Service Bulletin

Subject: UX Touch Screen Controller Field Rework EMEA

Models: Frymaster Touch Screen Fryers Serials # starting with 2602 – 2605 (excluding Intuition and Merco)

8/04/2026

Figure 1

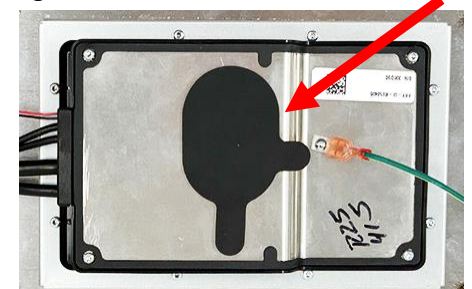
The new touch screen controller looks identical to the previous controller from the front (see Figure 1). It can be identified from the front of the fryer by pressing the home button, pressing the software version and the controller software begins with a **UIX** prefix. The rear of the controller looks different than its predecessor (see Figure 2).

Figure 2

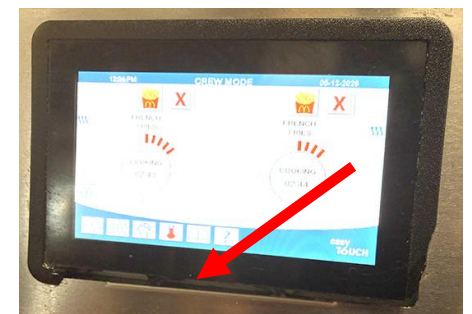
There have been some instances of the new controllers plastic bezel cracking (see Figure 3). A rework kit PN 8263964 that consists of a new bezel and frame attachment has been created. The kit will replace the bezels and frame attachment on all new style touch screen fryers (excluding Intuition and Merco), with serial numbers that start with 2602 – 2605, that are identified by the software prefix that starts with **UIX** and the rear that matches Figure 2.
